Work Order ID 117510

Item Name: Baggage Compartment Protector Floor

# DART SERVICE INSTRUCTION

TO AMEND INSTALLATION INSTRUCTIONS IIN-D407-781-2 REV. A OR LATER APPROVED REVISION  
AND INSTRUCTIONS FOR CONTINUED AIRWORTHINESS ICA-D407-781 REV. 3 OR LATER REVISION

**FIGURE 1 - D3879-1 BAGGAGE COMPARTMENT WALL  
PROTECTOR - ALTERNATE INSTALLATION**

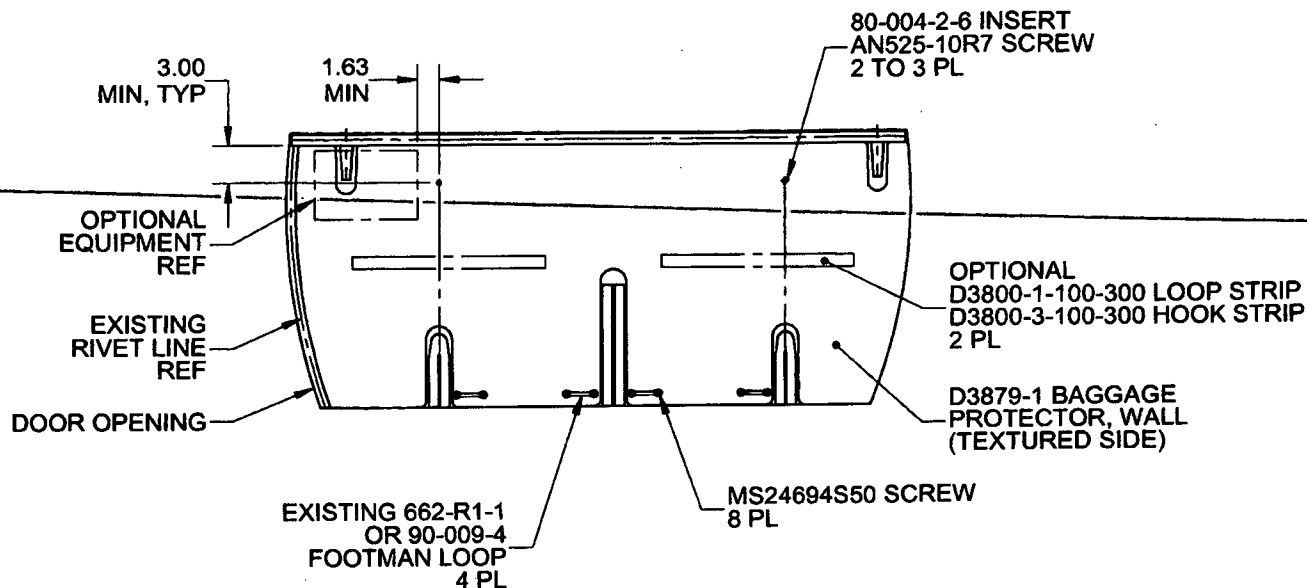
In some aircraft, the top portion of the D206-781-041 Baggage Compartment Wall Protector Kit cannot be installed as indicated in IIN-D407-781-2. The purpose of this DSI is to provide an alternate mounting method to fasten the top portion of the D206-781-041 Baggage Compartment Wall Protector Kit.

It is acceptable to replace qty(2) D3930-1 Clips with qty(2) 80-004-2-6 Inserts. Locate and mark location of the two attachment holes on the baggage compartment wall as shown in Figure 1 of this service instruction. Install 80-004-2-6 Inserts at the marked locations in accordance with Section 3-2-12 of BHT-206-SRM-1. It is acceptable to trim the wall protectors to accommodate optional equipment or transfer attachment holes to the wall protector and install the optional equipment on top of the wall protector with longer fasteners.
